# Plan Change Request

Site Address/ Parcel #: 0420222005 Permit #: PRCCP20251419  
 Owner: EJ Fernandez Email: ej@auuinc.com  
 Design Engineer: Justin Jones Email: justin@jnjteam.com  
 Contractor: T Barger Dirtworks LLC Email: tim@tbarger.com

Project:  
**Todd Rd Sewer Extension**

SHEET TITLE:  
**Proposed Sewer Plan**

SHEET NUMBER:  
**C4-101**  
DWG: 12 OF 18

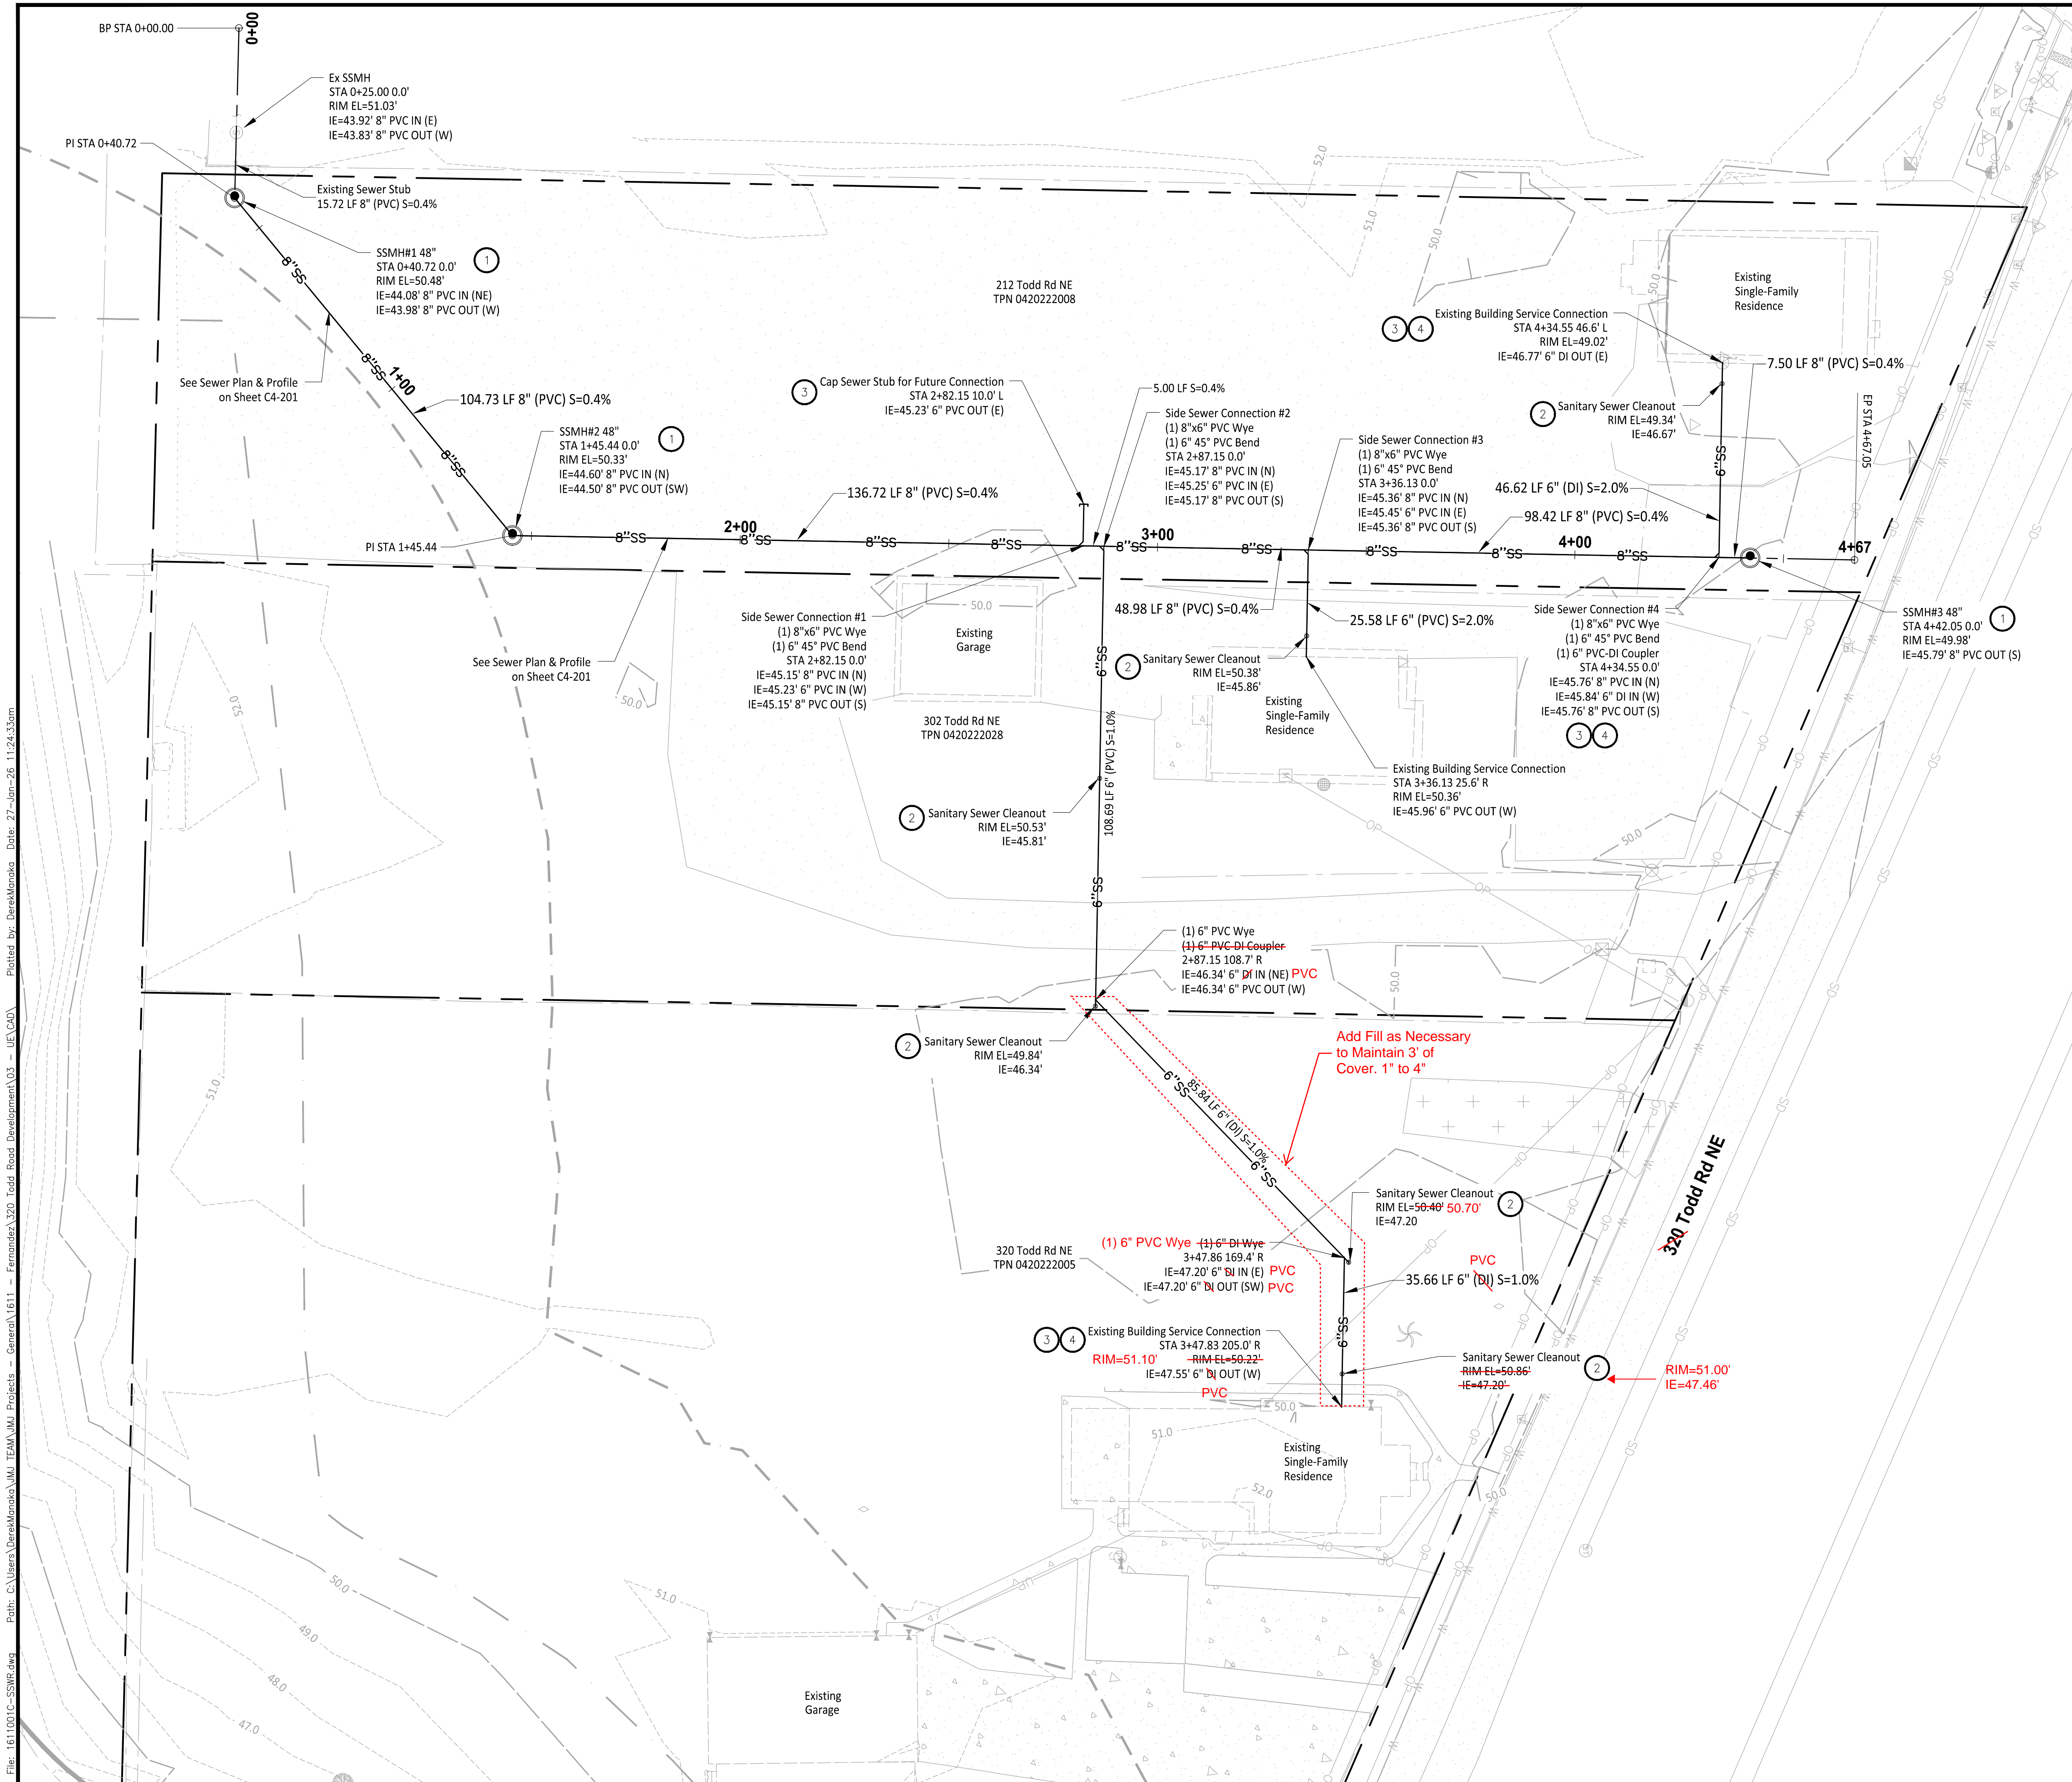
➤ Specify the approved civil plans affected: C4-101

Change of 6" sanitary sewer ductile iron pipe to 6" PVC pipe. After review, 6" PVC pipe will obtain 3' of cover with 1" to 4" of additional fill. Change also reflects areas of fill.  
 Change to surface elevation and cleanout IE at existing building service connection. Previous elevations were mistaken and the change shall reflect the appropriate existing and proposed conditions.
